Agenda Item 4. Padnall Lake (Pages 1 - 13)

Barking and Dagenham Council Planning Committee – Report Addendum		Date: 27 th November 2020
Application No:	20/01686/FULL	Ward: Chadwell Heath
Address:	Padnall Lake, Padnall Road, Romford, RM6 5ER	
Development:	‘Hybrid’ planning application seeking detailed planning permission for Phase 1 and outline planning permission for Phase 2, comprising: Outline Planning Permission (all matters reserved) for erection of buildings comprising up to 219 residential units (Use Class C3), up to 300 square metres (GEA) of flexible floorspace for residential use (Use Class C3) or non-residential use (Use Class D1), open space and public realm, means of pedestrian and vehicular access and circulation, car parking and cycle parking, and associated works; and Detailed planning permission for erection of buildings ranging between 3 and 6 storeys (Plots 1, 2 and 3) comprising 81 residential units (Use Class C3) and 181 sqm (GEA) of non-residential floorspace (Use Class D1), open space and public realm, parking and cycle parking, plant, other associated works; and associated infrastructure (Plot 4).

Air Quality Review V1 for 20/01686/FULL - Development Site a

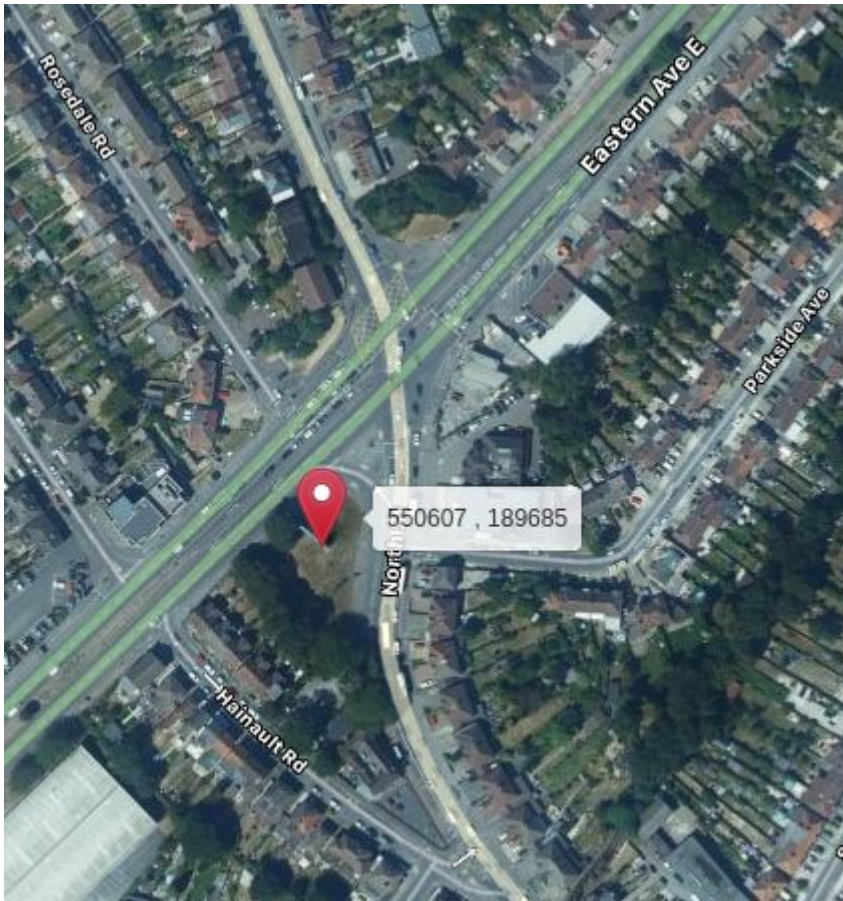
10. In Section 6.1.2 of the developer’s AQA, they specify which data is used for baseline verification, and describe two diffusion tubes located in the Borough of Havering. These are a triplicate: HAV13,14,15 and a site HAV39. These are described as being “between 2 and 3 km east of the site” (page 20, para 5), but their Table 6.1 on page 20 states that they are ~2.2km and ~3.5km from the site respectively so would more accurately be described as being between 2 and 4km from the site.
